VILLAGE OF WILLOWBROOK
STAFF REPORT TO THE PLAN COMMISSION

Case Number and Title: PC-16-02

Action Requested: Approval of a setback variation from 30' to 23.3' to accommodate a 12'X14' sunroom

Location: 7806 Clarendon Hills Road
Willowbrook, IL 60527

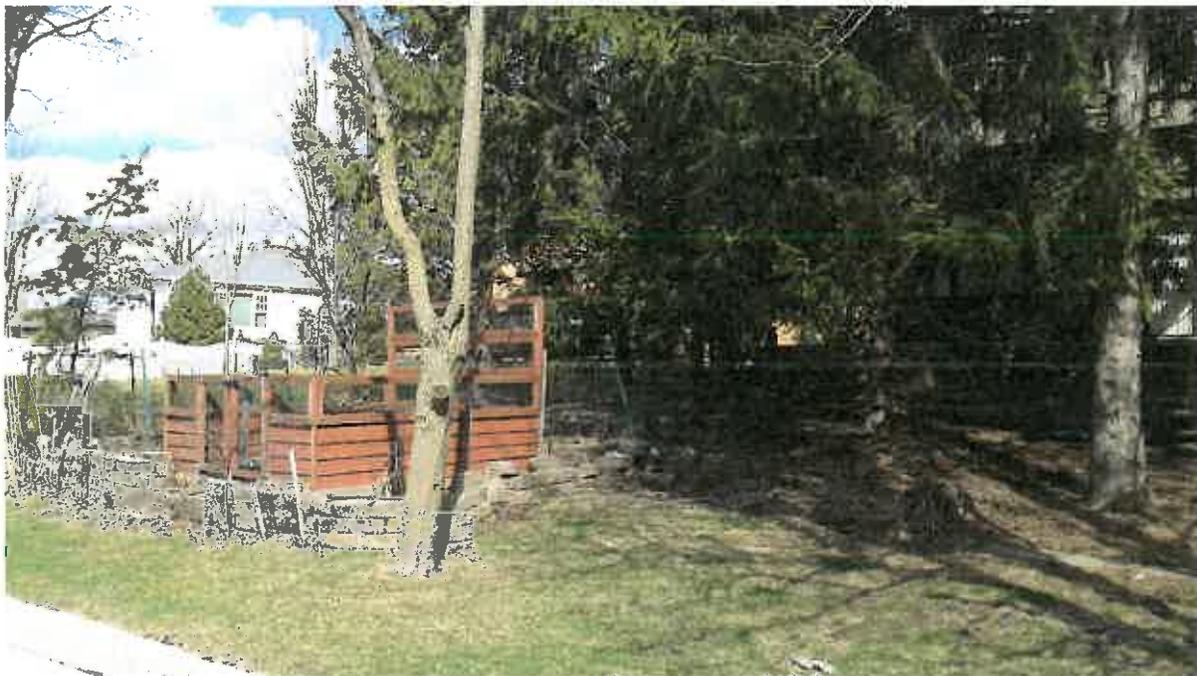
The applicant is suggesting a 12' X 14' sunroom addition that will be attached to the principal structure. The original structure's square footage is recorded as 1,906 square feet, and the proposed addition totals 168 square feet. Together, the new total floor area of the structure would be 2,074 square feet.

The proposed addition would be located approximately 23' from the rear lot line, when 30' is required. Given the existing structure's 35.33' set back from the rear lot line, an addition in conformance with the zoning ordinance would allow for an addition of only about 5', which is not a reasonably sized sun room addition. A 12'X14' addition is a reasonably sized sunroom for this property, but requires a 7' encroachment into the rear yard.

SUN ROOM FLOOR PLAN

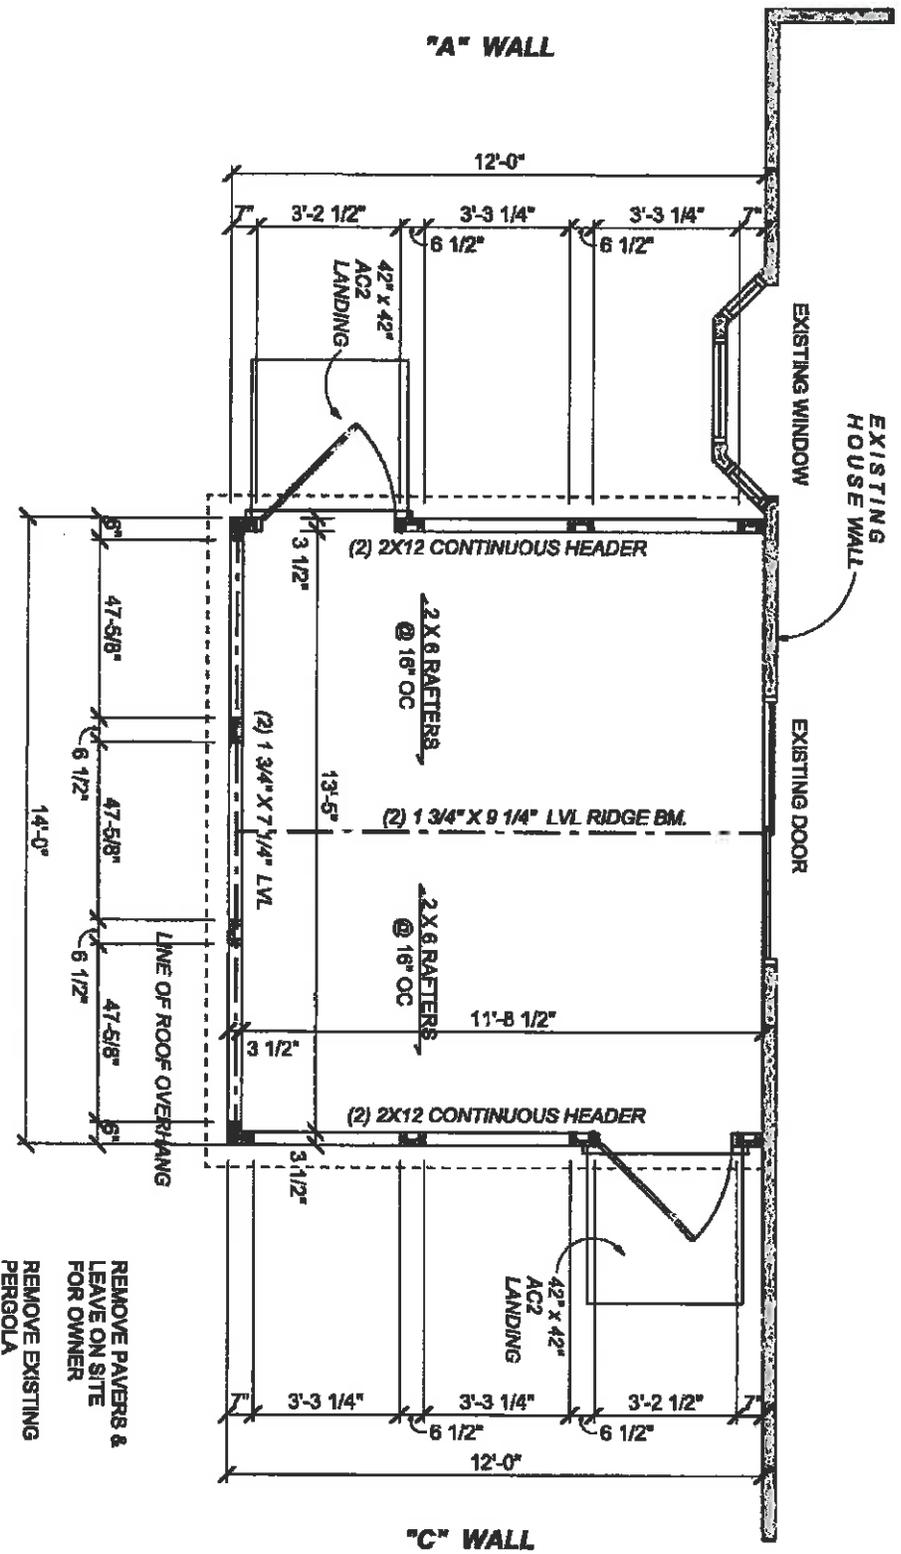
The lot is zoned R-3, which has Bulk Regulations in terms of accessory use buildings. The Village Code states that when an accessory use building is structurally attached to the principal building, it is subject to conform to a variety of regulations. The applicable regulation for the attached sunroom includes that the attachment must meet the setback requirements for the principal structure (30') and should not be used for storage purposes. The proposed sunroom is not intended to be used for storage purposes.

PLAT OF SURVEY

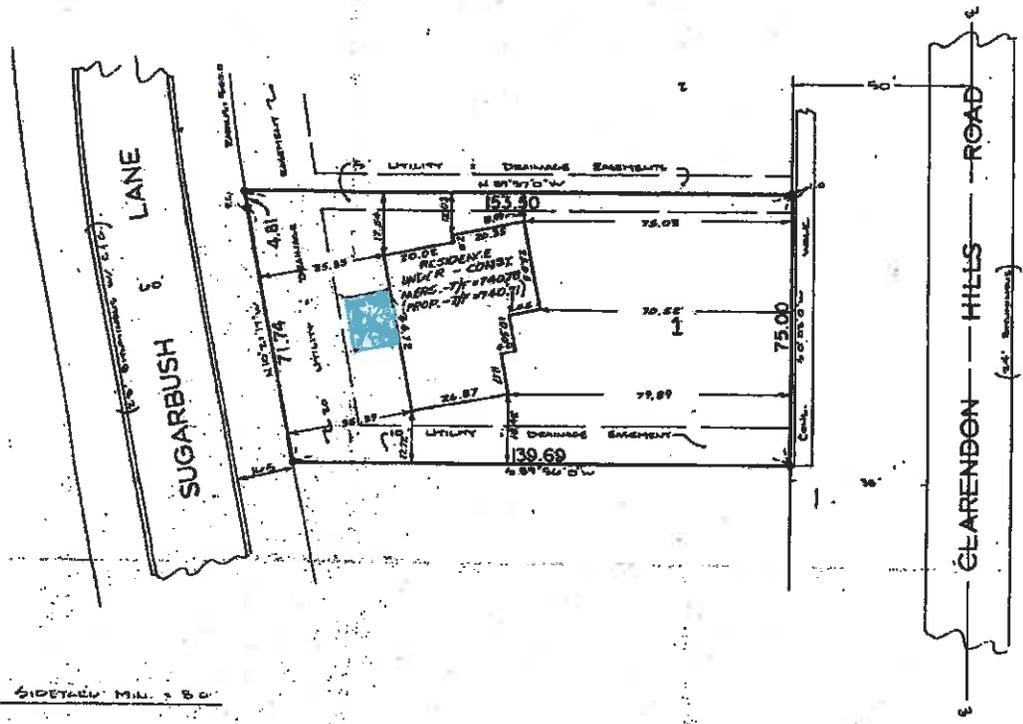
Pursuant to the application process, staff conducted an on-site review of the property that revealed various structural improvements for a garden are improperly located in the Sugarbush Parkway. See picture below. No permits for these improvements were granted, and these types of improvements in the right-of-way are not allowed and must be removed. Later visits to the site showed that the block retaining wall had been removed, but the wooden vegetable garden structure remained. In order to be in compliance with the Zoning Ordinance, these improvements must be removed or moved so they are no closer than five feet (5') to any lot line.

Any remaining retaining wall and structural raised garden improvements that are less than 5' from any property line must be removed as it is both in violation of the current ordinances and would also prevent the Village Board from considering any recommendation granting the requested variation.

The proposed sunroom will provide the homeowners with additional space that will increase the value of their property as well as the Sugarbush Subdivision's overall appearance. So long as the existing retaining wall and raised vegetable garden bed in Willowbrook's parkway is reallocated to a different location on the lot in a manner that it is no closer than five feet from any lot line, the property and the sunroom will not infringe on any other Village codes. The owners will need to remove these improvements prior to any recommendation being forwarded to the Village Board for consideration.
